Docket Item # 3
BAR CASE #2008-0167

BAR Meeting
October 15, 2008

ISSUE: Alterations
APPLICANT: John Huling
LOCATION: 219 South Royal Street
ZONE: RM/Townhouse zone

The applicant is requesting approval of a Certificate of Appropriateness for alterations to install a vent through an exterior wall at 219 South Royal Street.

Figure 1. View of south wall of 219 South Royal Street showing approximate location of proposed vent.

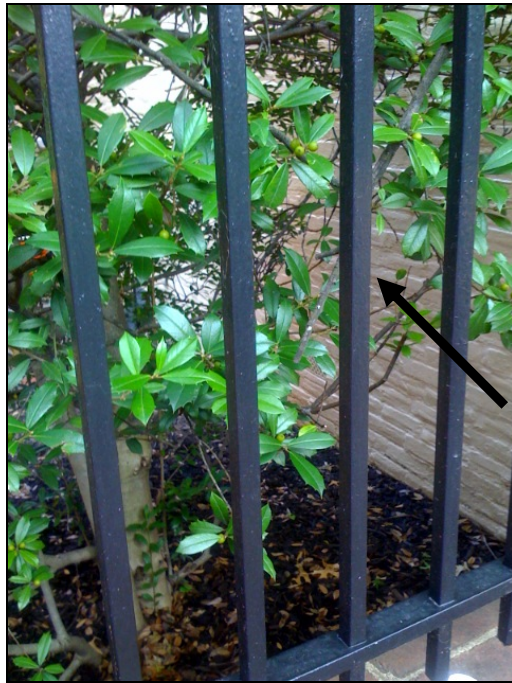
The exterior vent will be located about three feet from the ground on the south wall. The proposed vent will measure approximately 12"x12" and will extend about 4" from the existing wall plane. The applicant notes that it can be painted to match the exterior of the building. The unit will be more than partially screened by an evergreen bush on the neighbor's property. The applicant notes that additional shrubbery can be planted to fully screen the vent.

match the existing material. In this circumstance, Staff finds that the location of the proposed vent is minimally visible from the public right-of-way. In addition, the painting of the metal vent to match the existing painted masonry, as well as the planting of additional shrubbery as needed, will make the vent nearly undetectable from South Royal Street. Staff has no objection to the installation of this exterior vent.

STAFF RECOMMENDATION: Staff recommends approval of the application with the condition that the exterior vent be painted to match the already-painted masonry wall and that additional shrubbery be planted as necessary.
